September 8, 2020  
Subject: Salt Storage Building  
State WIN: 026231.00  
Location: **Randolph**  
**Amendment No. 1**

**RANDOLPH MAINTENANCE SALT BUILDING**  
**FRAMING DETAILS**

SHEET NUMBER  
**15**  
 OF 18

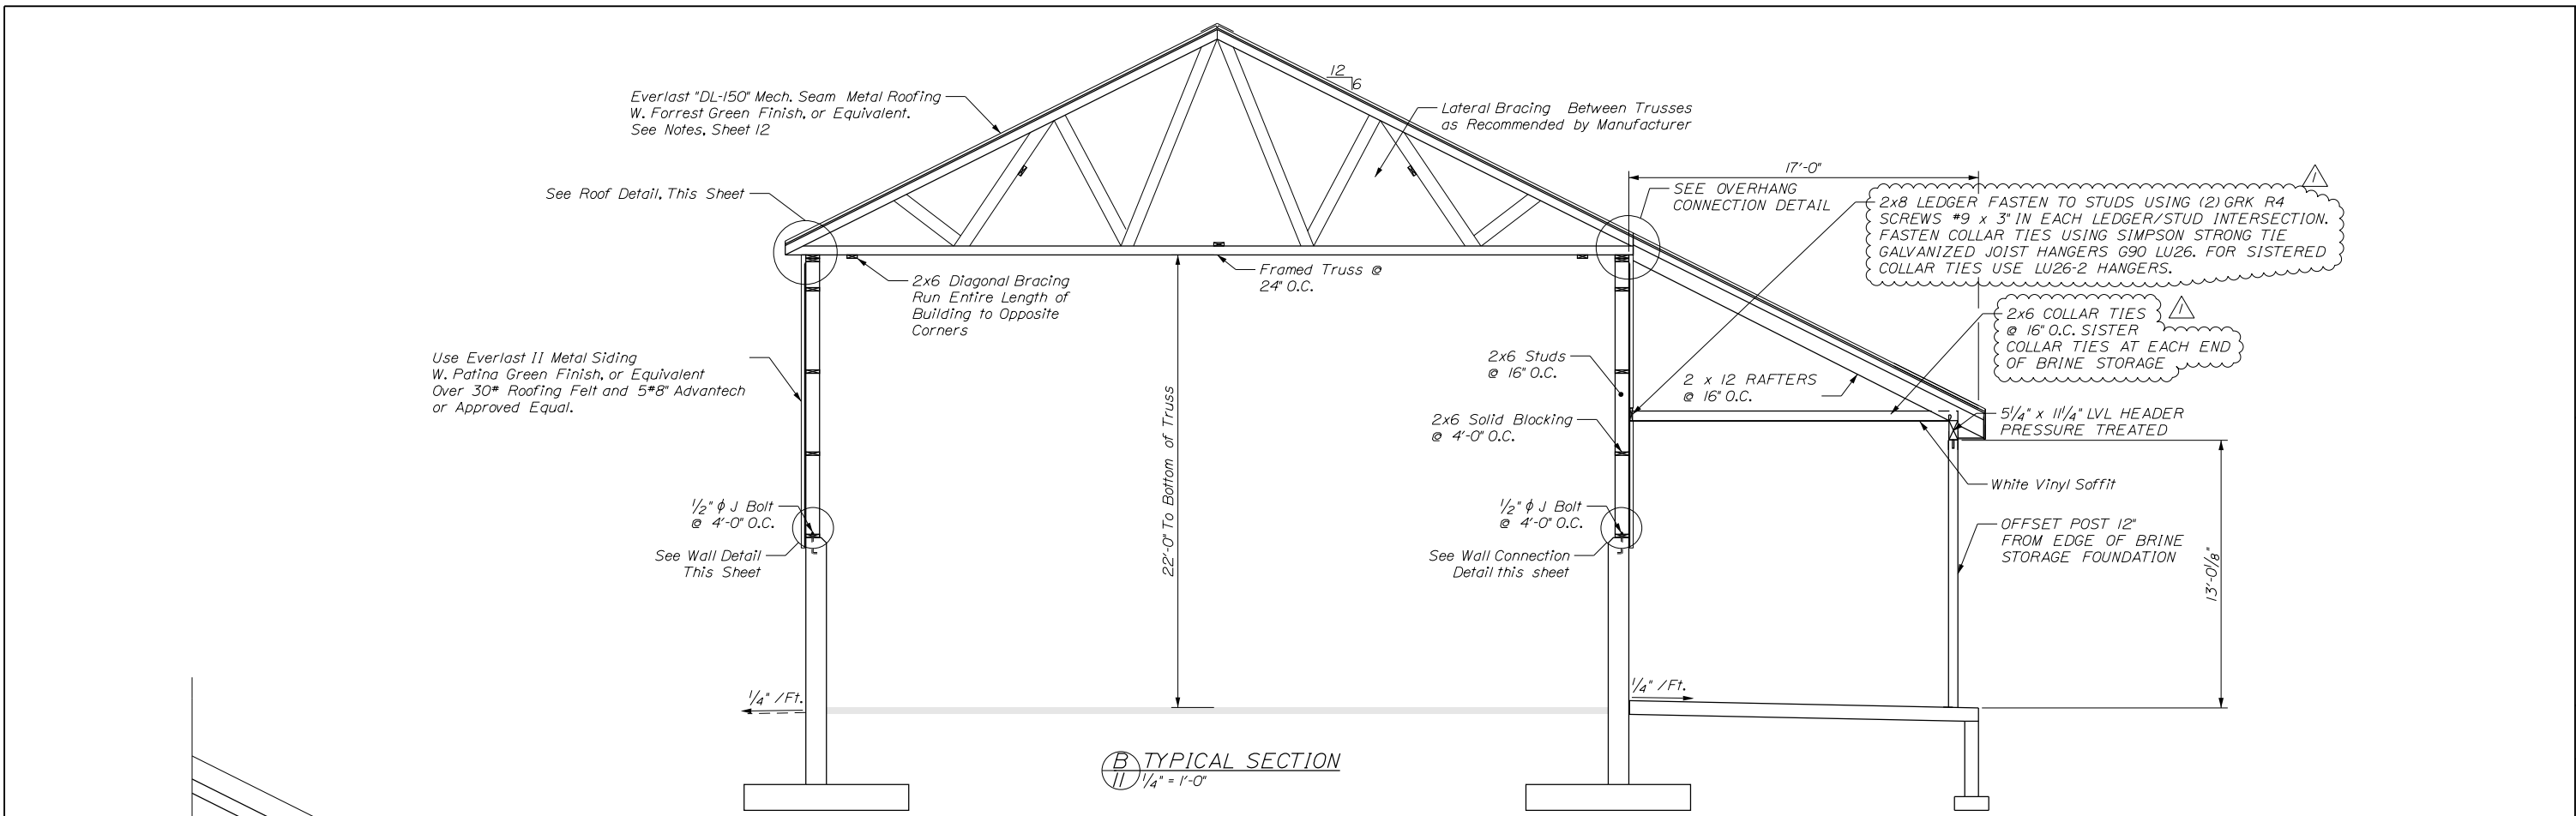
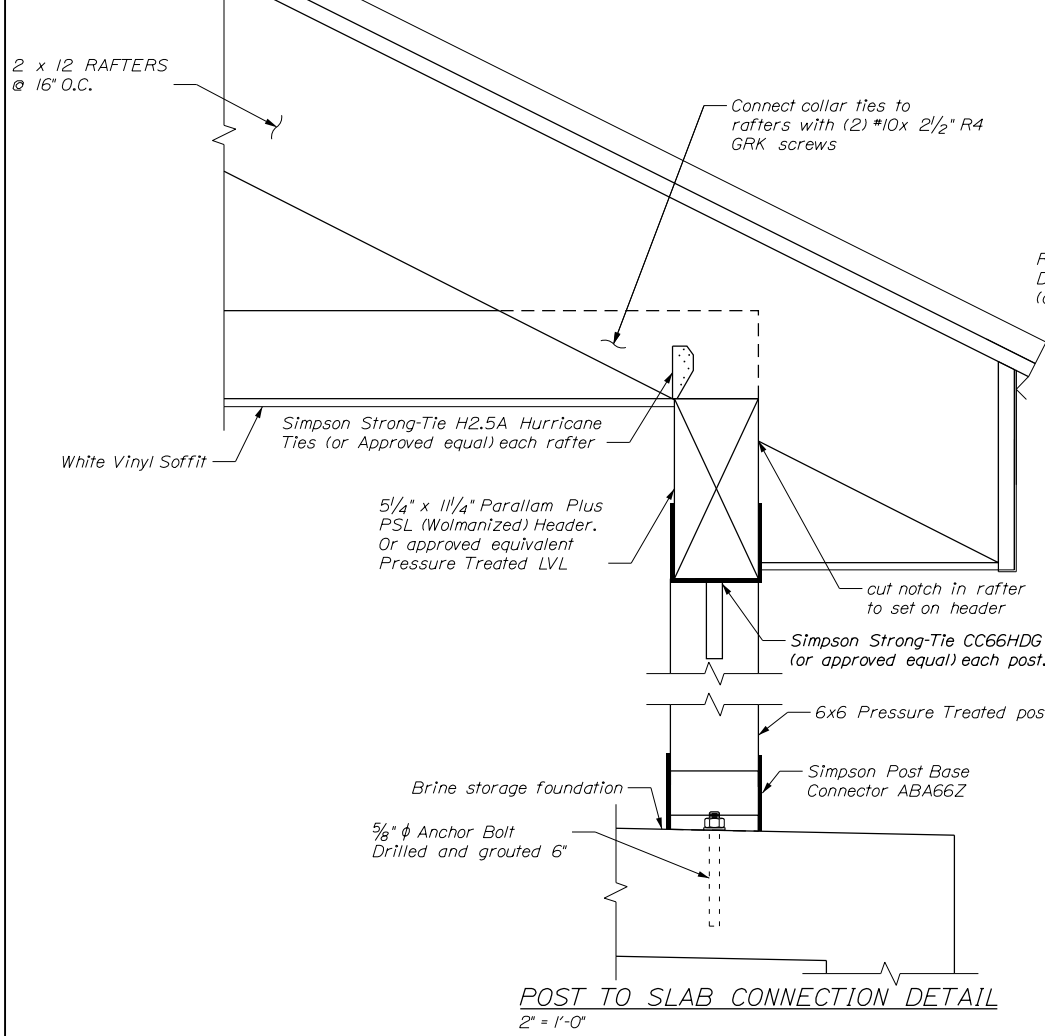
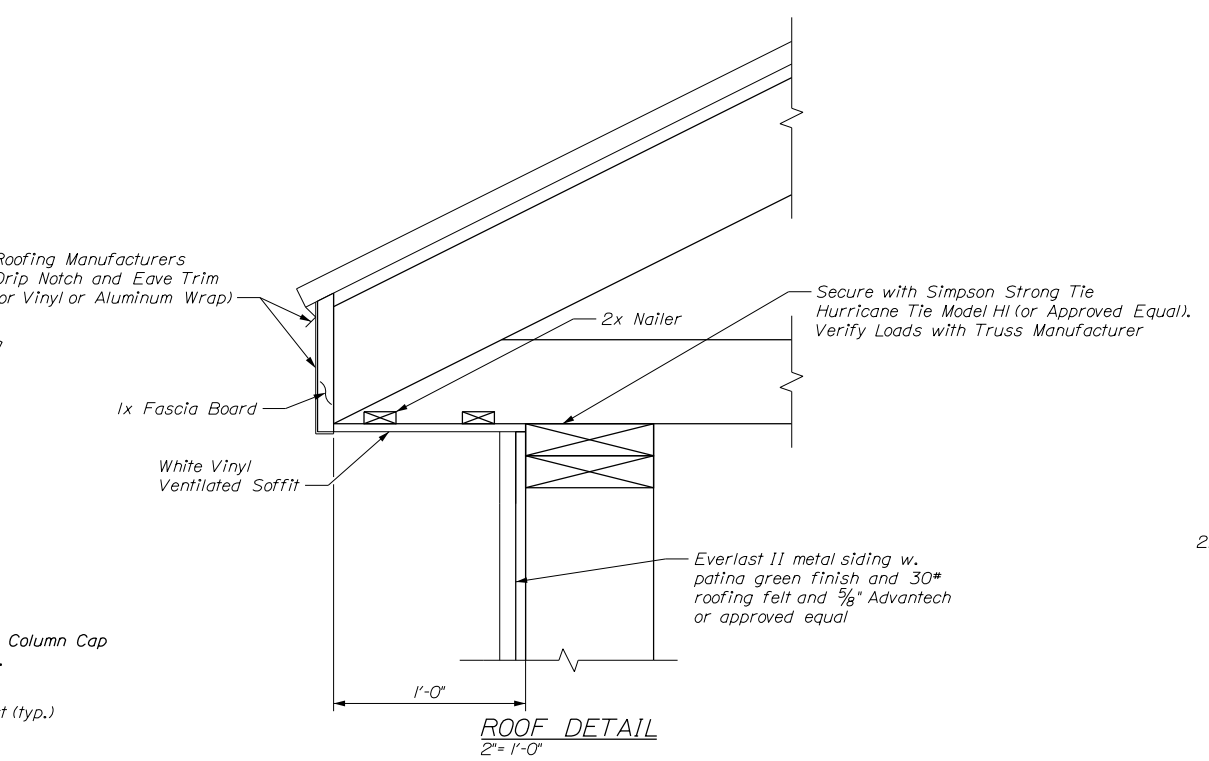
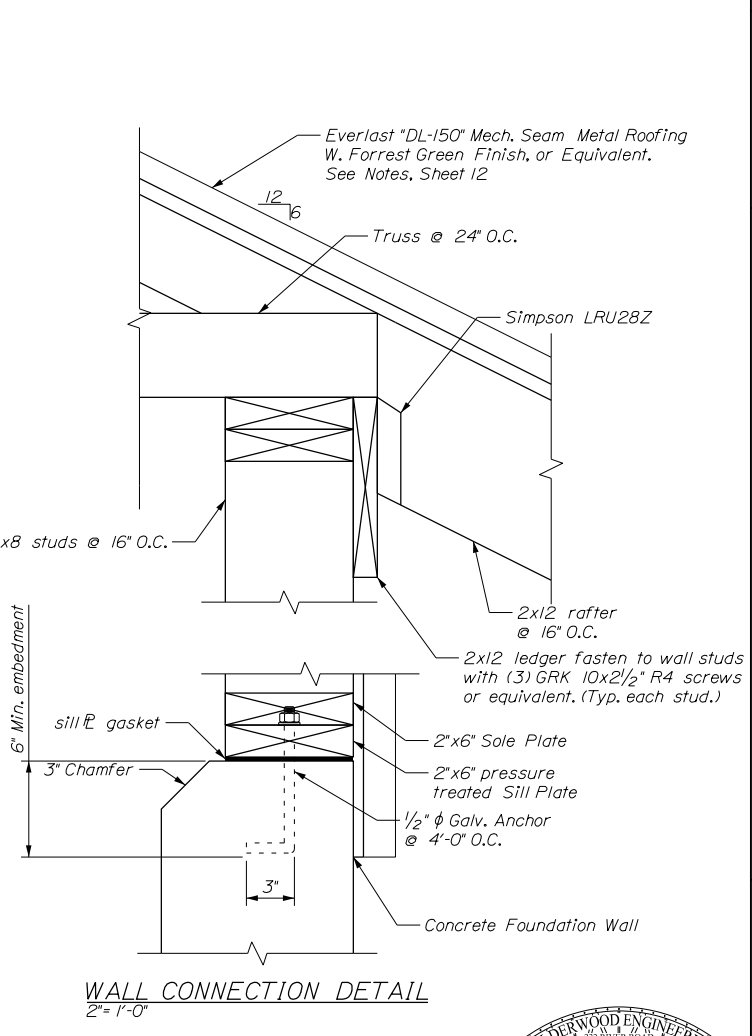
**REMOVE SHEET NUMBER 15 OF 18, FRAMING DETAILS, and REPLACE** with the attached, revised SHEET NUMBER 15 OF 18, FRAMING DETAILS.

**Question:** Plans show 2x6 shed roof collar ties 4' OC with vinyl soffit below. This framing is not adequate to properly support the vinyl soffit. How should the ceiling of the Brine Storage area be framed to provide the needed support for the soffit material?

**Question:** How are collar ties attached to building?

**Question:** At the roof for Brine Storage area, no beam is indicated returning to the building from the PSL beam to support the framed upper end walls. What should be used to support this framing?

**Response:** The 2x6 collar ties should be at 16" centers.

**Response:** Collar ties are to be attached to a 2x8 ledger beam fastened to the studs using GRK R4 screws (or equivalent) #9 x 3" screws (2) required per stud - ledger beam intersection - collar

ties to be connected to ledger beam using simpson strong tie galvanized joist hangers G90. Siding should be installed above and below the ledger.

**Response:** At each end 2x6 collar ties should be sistered at this location and will support the gable framing.
